## SB 4500-01 Service Bulletin (Mandatory)

Regarding: Grounding of bezel assembly

SN4500-xxx Primary Navigation Display serial numbers 9-1001 through 9-1012

**Figure 1. Bezel Mounting Screws**

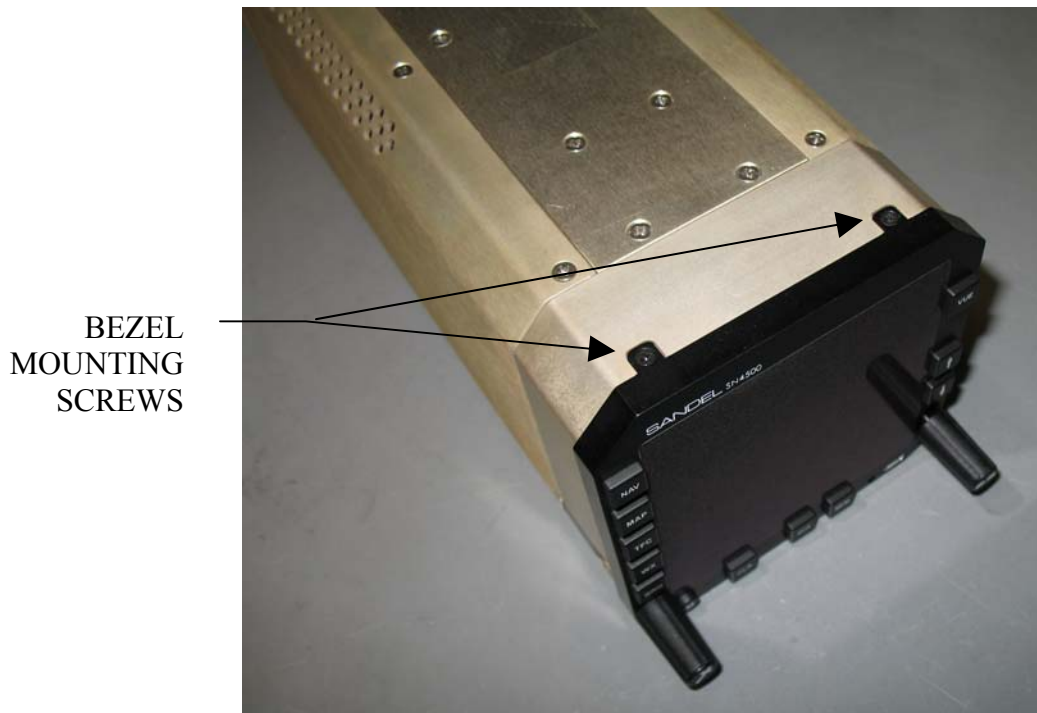
1. Loosen the instrument clamp and partially pull out (or remove fully, if desired) the SN4500 from instrument panel.
2. Remove up to four (but at least 2) of #2-56 x .125 bezel mounting screws, and retain for reinstallation. Bezel mounting screws are located on top of unit and in lower corners (Figure 1). Be careful as these screws are very small.

**Figure 2. Remove Finish Using Provided Countersink**

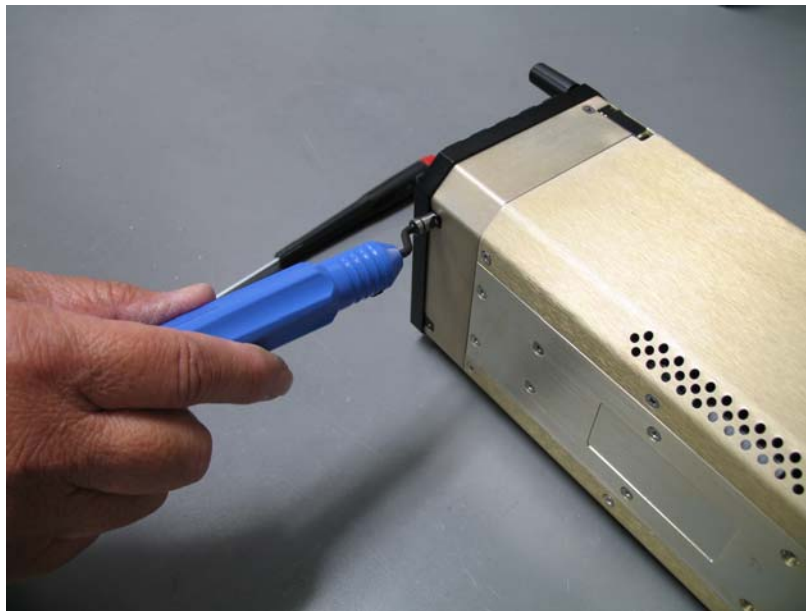
3. Using the provided 82° countersink tool, remove gray paint or black anodize finish from the countersink holes. Use caution to prevent chips or other foreign material from entering interior of SN4500 (Figures 2 & 3).

## **Figure 4. Verify Continuity Between Bezel and Chassis**

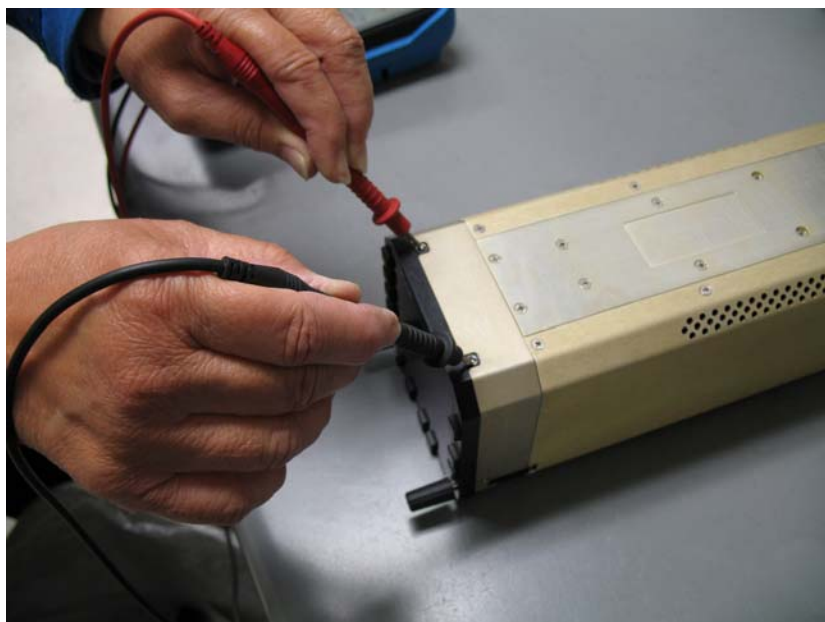
4. Reinstall Bezel Mounting Screw. Torque hand tight. Do not overtighten. (Ref: approx 2.5 in-lbs).
5. After reinstalling all but the last bezel screw, verify continuity of cleaned bezel area to SN4500 chassis with a reading  $<1$  ohm (Figure 4).
